DECISION, CONDITIONS, FINDINGS OF FACT AND CONCLUSIONARY FINDINGS OF THE MCMINNVILLE HISTORIC LANDMARKS COMMITTEE FOR THE APPROVAL OF AN ALTERED BUILDING AT 903 NE THIRD STREET WITHIN THE DOWNTOWN DESIGN AREA

DOCKET: DDR 5-19 (Downtown Design Review for Alterations including Waiver Request)

REQUEST: Approval of a Downtown Design Review application to allow for an addition to the existing building at 903 NE 3rd Street that infills the existing building perimeter walls under the existing covered area on the south side of the building. The proposed work includes alterations to the existing building façade as part of the addition, including new storefront windows, new façade materials, new awnings, and an updated fascia and cornice.

Glazing Waiver on 3rd Street Façade – Waiver from Section 17.59.050(B)(3)(c)

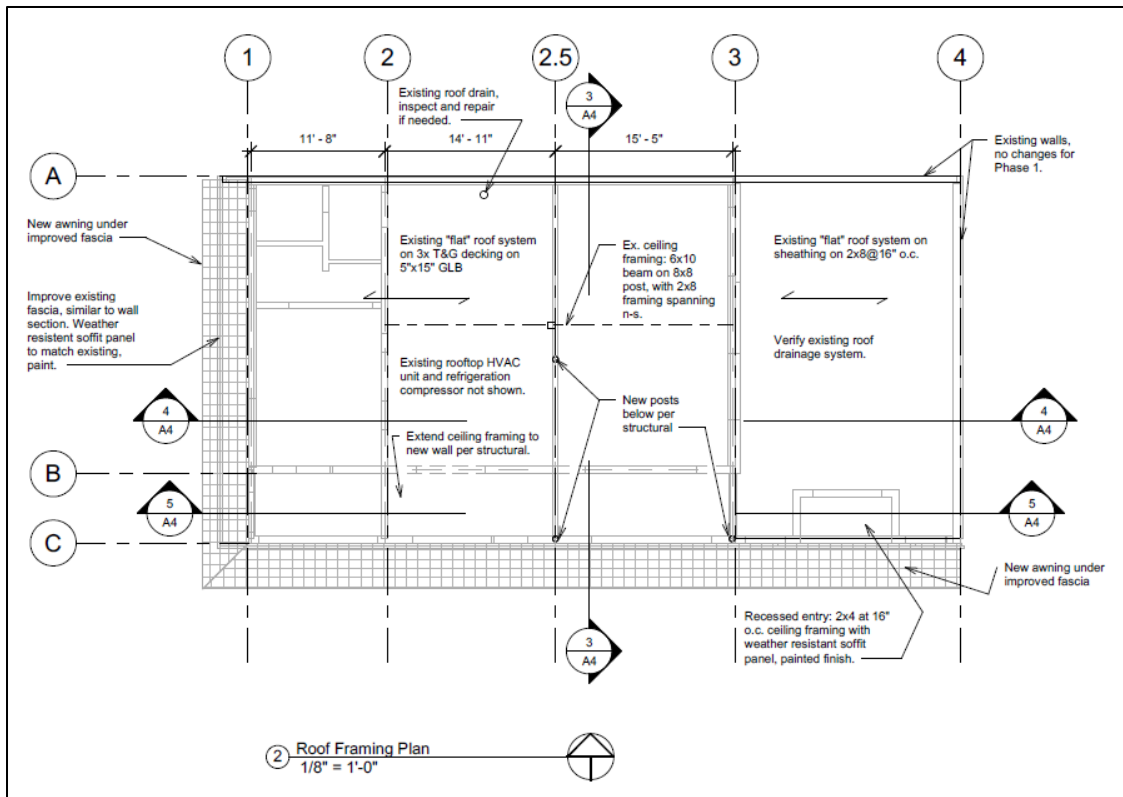
APPLICANT'S RESPONSE: There is a demonstrable difficulty in meeting the glazing requirements of this Chapter due to the existing structure. The existing original structure is unreinforced masonry walls (concrete block) supporting an existing wood heavy-frame roof system. The existing roof framing system divides the existing building into structural bays which affect the new window placement.

The existing east addition is a wood frame structure that will have new openings added to the Third St. façade for a new recessed entry, and new windows.

New wall construction is to be 2x6 wood frame, with three new steel columns and foundations supporting the existing roof beams. The new wall facing Third St. will have new openings, however, a new shear wall is required along this new wall, and it needs to be located with a new column under an existing roof beam. The 5'-6" wide shear wall shown is the minimal length required to improve the existing structure along gridline C. Except for the shear wall, there are small parts of solid wall separating sets of windows.

FINDING: SATISFIED. The City concurs with the applicant's findings, and adds that the applicant provided roof framing plans that identify the proposed construction methods of the addition. The roof of the addition is proposed to be extended off of the existing building's roof framing system, necessitating the three new columns and foundations described by the applicant in the newly constructed south building wall. The roof framing plan can be seen below:

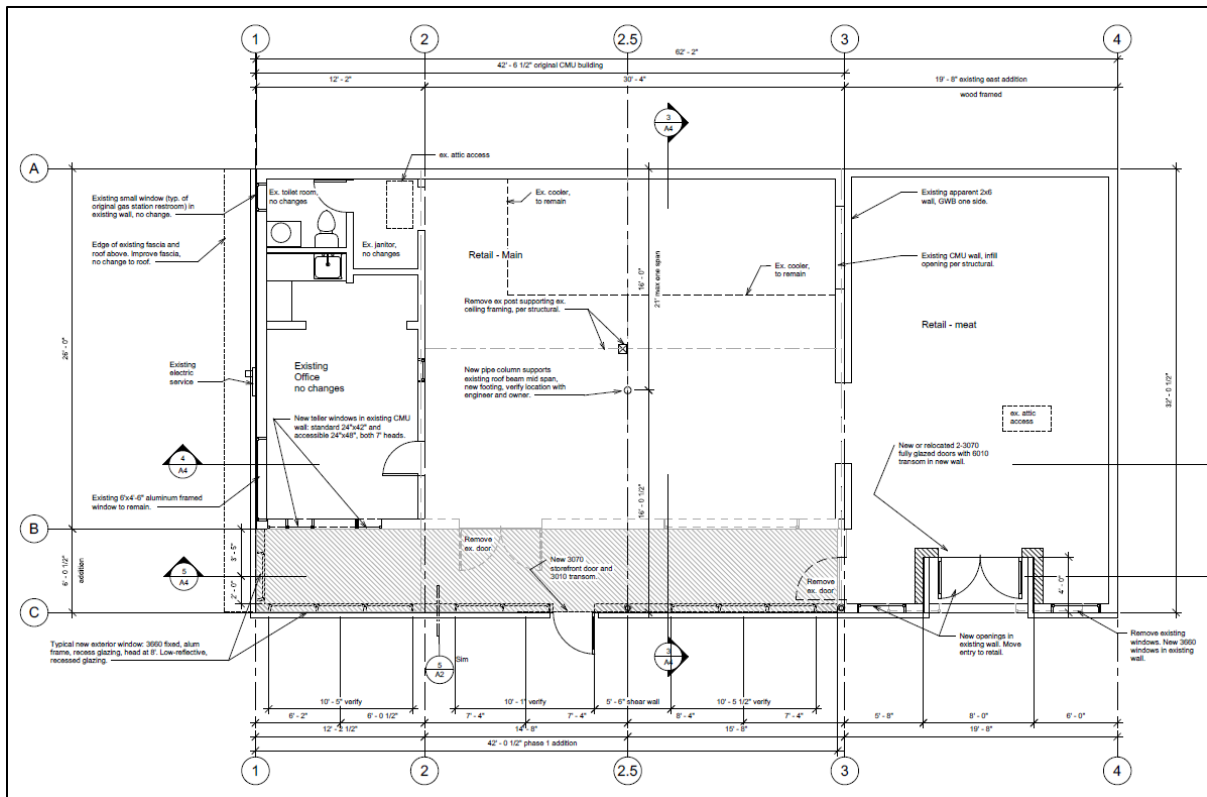
APPLICANT’S RESPONSE: Due to the structural requirements of the existing building, this waiver is requesting the minimum glazing change necessary to alleviate the difficulty of meeting the design standards for glazing.

FINDING: SATISFIED. The City concurs with the applicant’s findings.

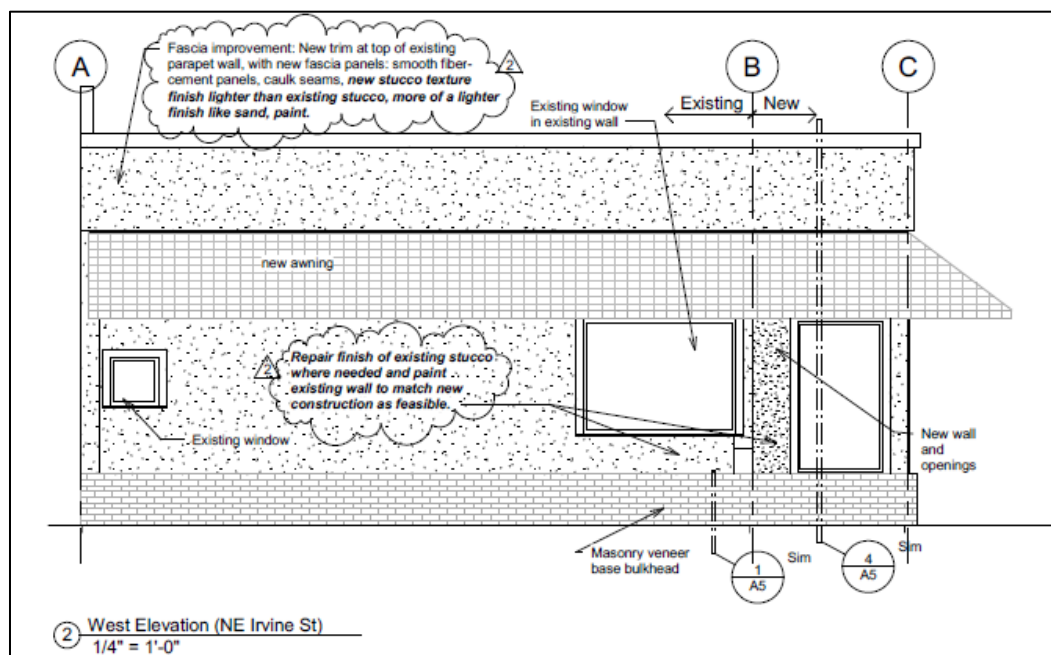
APPLICANT’S RESPONSE: The proposed new construction along Irvine St. facade is 6' long (fitting under existing roof), with a new window that matches the new Third St. façade windows. Matching the new window sizes in new construction for this corner facade is good design.

There will be a 2' brick veneer bulkhead required by design standards.

There will be 44% glazing in this minimal new wall. The entire west wall will be improved from 15% to an overall 20% glazing.

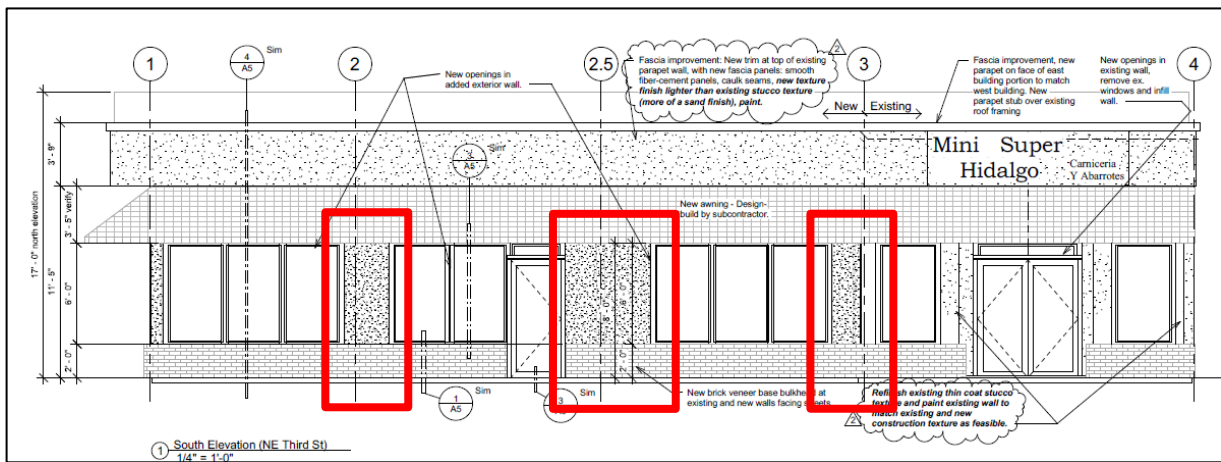
APPLICANT’S RESPONSE: The existing building is 62’ wide along Third St, and 32’ along Irving St. The façade improvements (grouped windows, new recessed entry, brick base, awning, fascia along existing parapet) are along the existing building street facing perimeter. A recessed doorway provides visual subdivision. The proposed new awning is continuous. The new windows facing Third St. are grouped in proportional bays, and walls between the window groups will appear to vertically divide the bays.

FINDING: SATISFIED. Staff concurs with the applicant’s findings. The proposed south (Third Street facing) façade can be seen below, with the proportional bays and vertical divisions identified. The vertical divisions appear in the form of solid building walls, which are shown in the locations required for support columns under the expanded roof framing system.

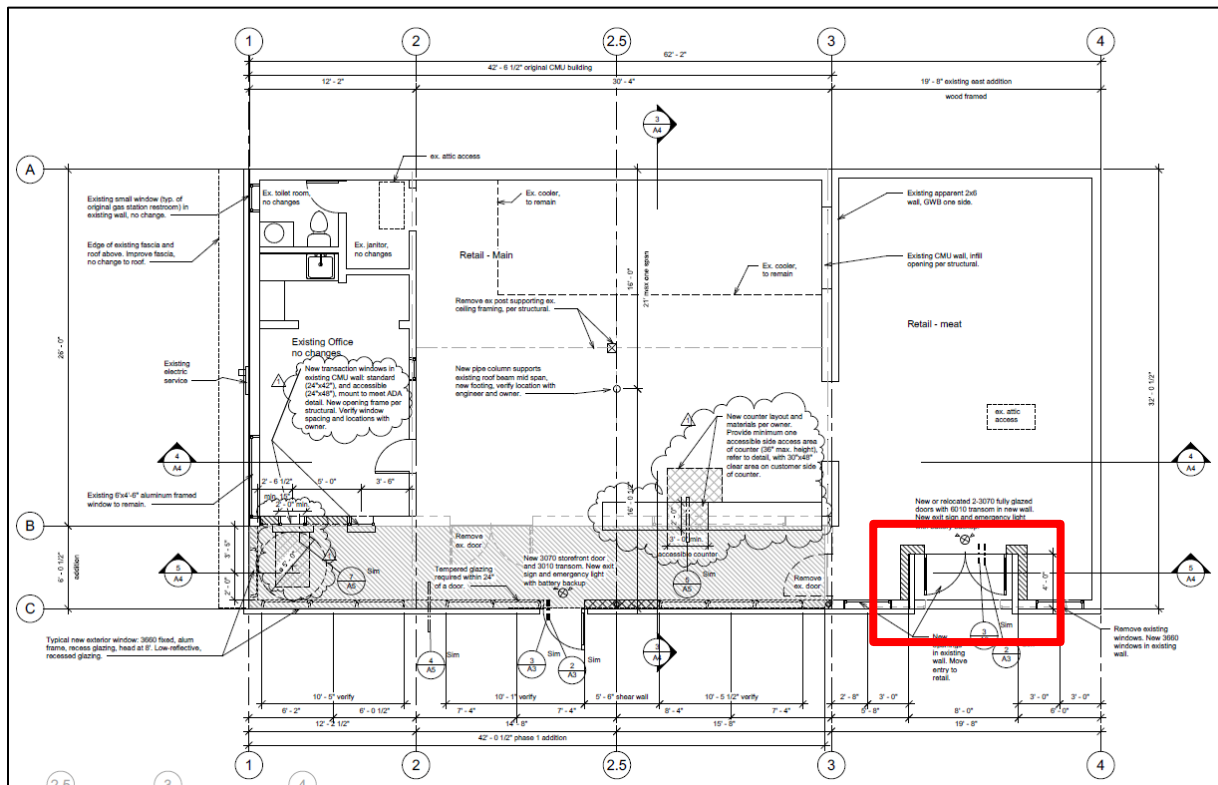
APPLICANT’S RESPONSE: Third St: A new recessed entry and transom with transparent door is provided at Third St. façade.

FINDING: SATISFIED. The City concurs with the applicant’s findings. The floor plan and rendering provided with the application materials depict the recessed entry and transparent door proposed on the south (Third Street facing) façade, as seen below:

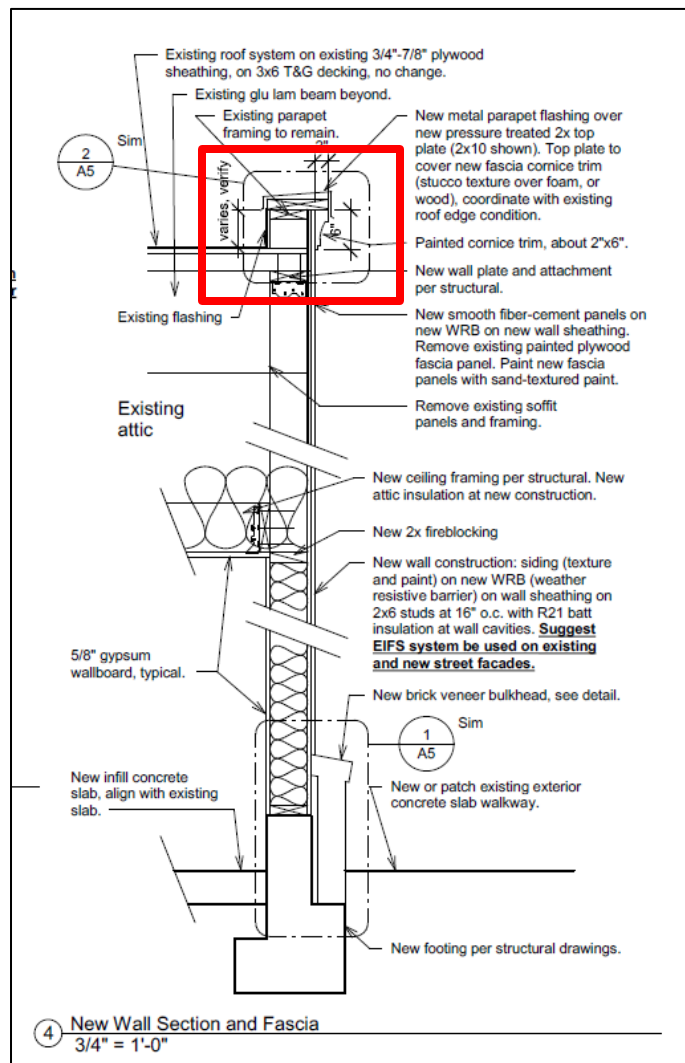
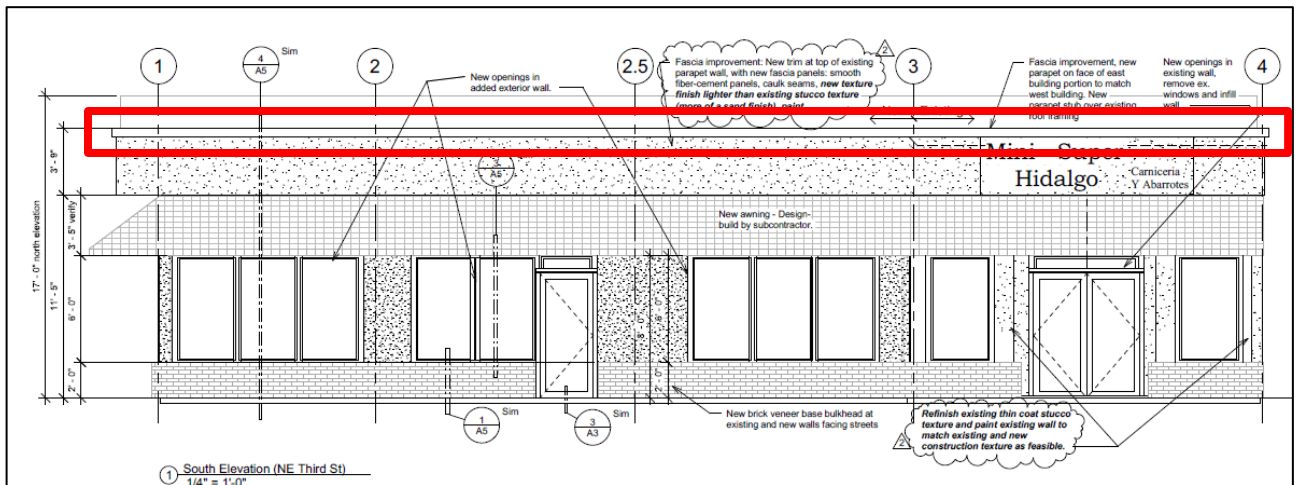
APPLICANT’S RESPONSE: A new decorative cornice or cap trim will be provided at the improved parapet façade at the roofline.

FINDING: SATISFIED. The City concurs with the applicant’s findings. The cornice/cap trim can be seen below:

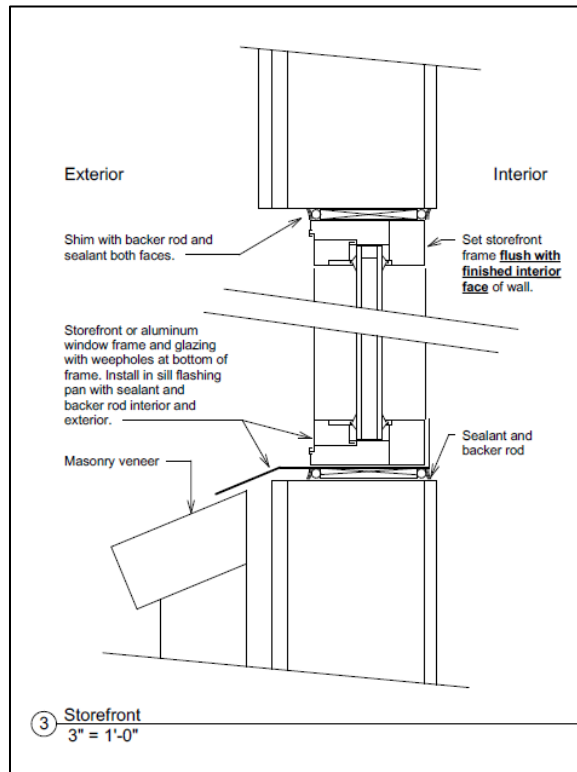
APPLICANT’S RESPONSE: New windows shall be installed so the glazing is recessed in the new wall, and not flush or project from the surface of the outer wall. New windows are oriented vertically.

FINDING: SATISFIED. The City concurs with the applicant’s findings. A detail showing the windows recessed was provided by the applicant as shown below:
